APPENDIX A

A2. Correspondence

- i. 1st Submission Comments***
- ii. Meeting Minutes***
- iii. Hydrologic Modelling***
- iv. Buffers and Allowances***

**DRAFT PLAN OF SUBDIVISION
ORLANDO CORPORATION**

Project No.	99067A
Date	MARCH 2000
Scale	1:20,000
Figure No.	2

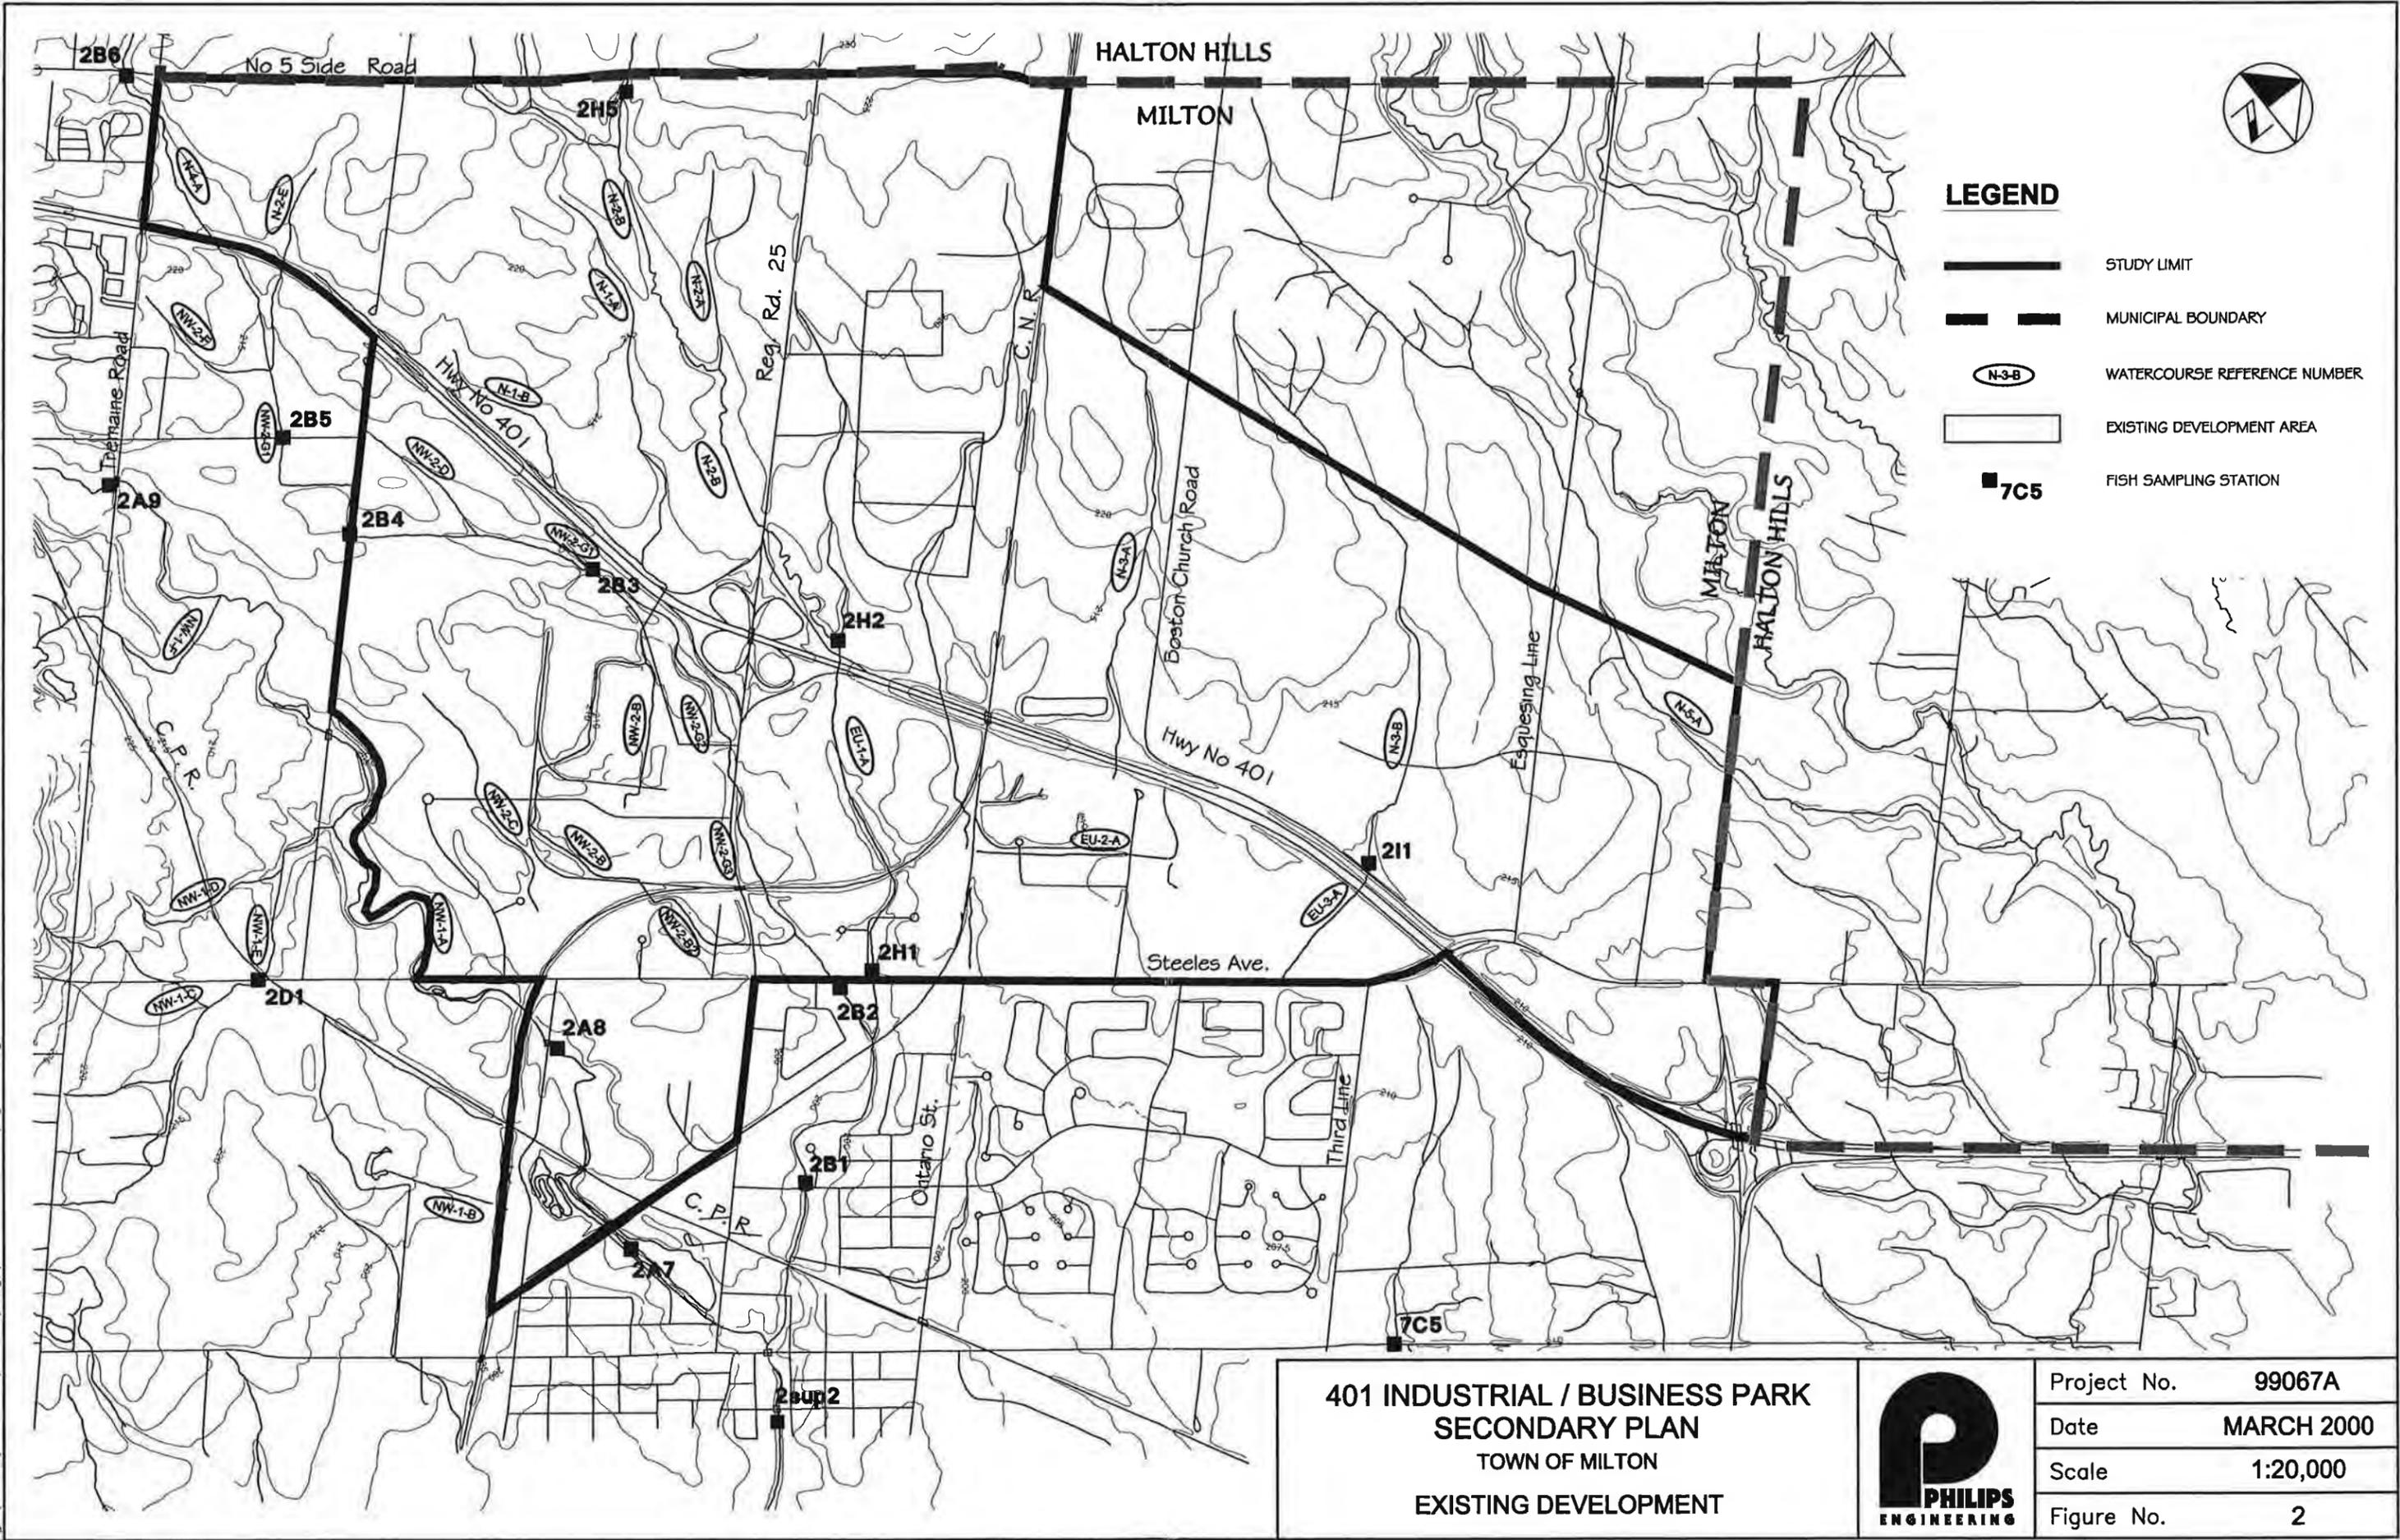
- The report ends at page 64. Was it intended that any further information be included subsequent to this page?
- Figure 2 identifies existing development in the Study Area. Staff note that there is existing development at the northwest corner of Steeles and Industrial Drive (Hands Fireworks), that is not shown on the Figure.

Project No.	99067A
Date	MARCH 2000
Scale	1:20,000
Figure No.	3

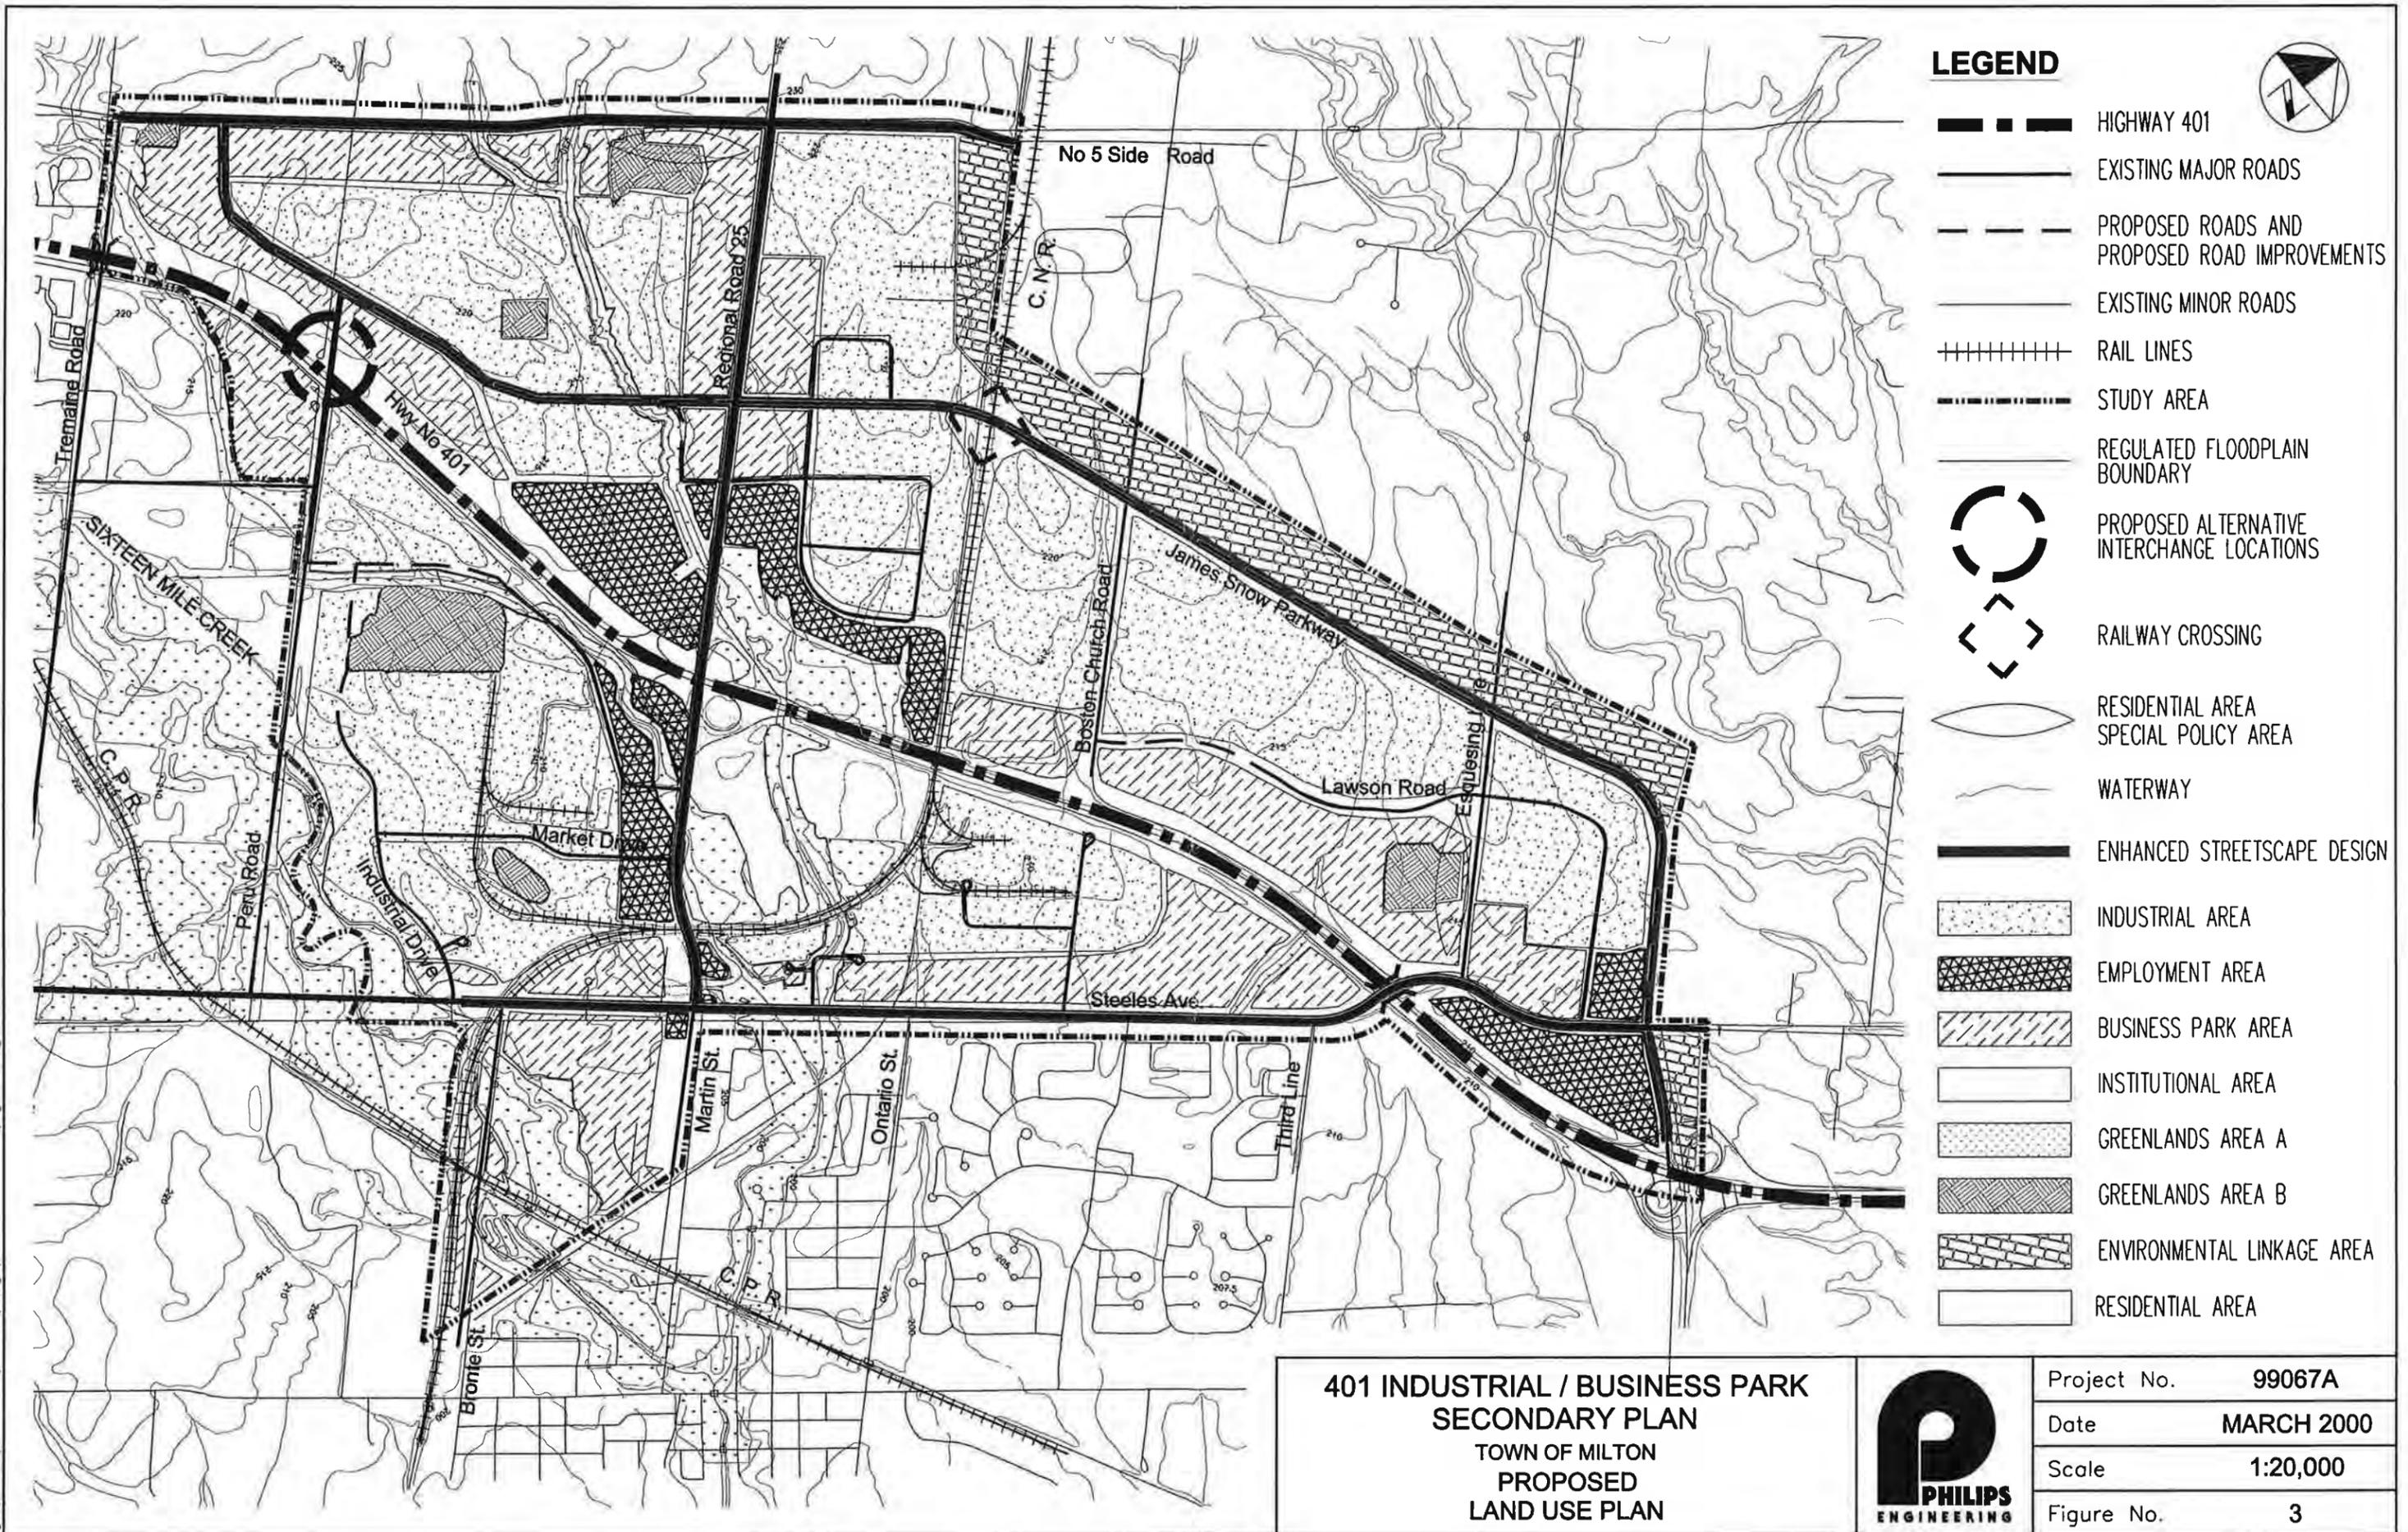
- Staff are unclear as to why the reference numbers for watercourses change downstream of Highway 401 (i.e., EU-1-A is the downstream reach of N-2-B).
- Figure 3 - an "enhanced streetscape design" overlies Unit 156. Redesign of the streetscape must take into account the high constraint rating of this feature.

- Figure 3 - the woodlot designation on the Toronto Auto Auctions property should be removed. In addition, staff question whether it is intended to maintain the woodlot within the central portion of the High Point West lands as it is not identified on Figure 3.

- Figure 3 identifies two proposed interchange locations along Highway 401. It was staff's understanding that only the interchange at Dublin Line/Peru Road was being proposed.
- The ponds on the Robertson-Whitehouse property, on Bronte Street, are being rehabilitated to function as a wetland feature. Staff recommend that Figure 5 should identify this area as a medium constraint terrestrial feature at a minimum.
- Figure 9 - there is an existing "quantity" control facility at the northwest corner of Steeles Avenue and Industrial Road however, it is unclear as to the exact function of the facility. Staff recommend that it may be appropriate to indicate the location of the existing facility. Also, as per the comments regarding Figure 3, the woodlot designation on the Toronto Auto Auctions property should be removed.

Figure 3, Proposed Land Use Plan, watercourses EU-3-A and N-3-B should be shown as a Greenlands A Area as the watercourse is fill regulated by Conservation Halton and will most likely not be eliminated, especially south of Lawson Road, as there are existing plans for the construction of an on-line stormwater facility between Lawson Road and Highway 401.
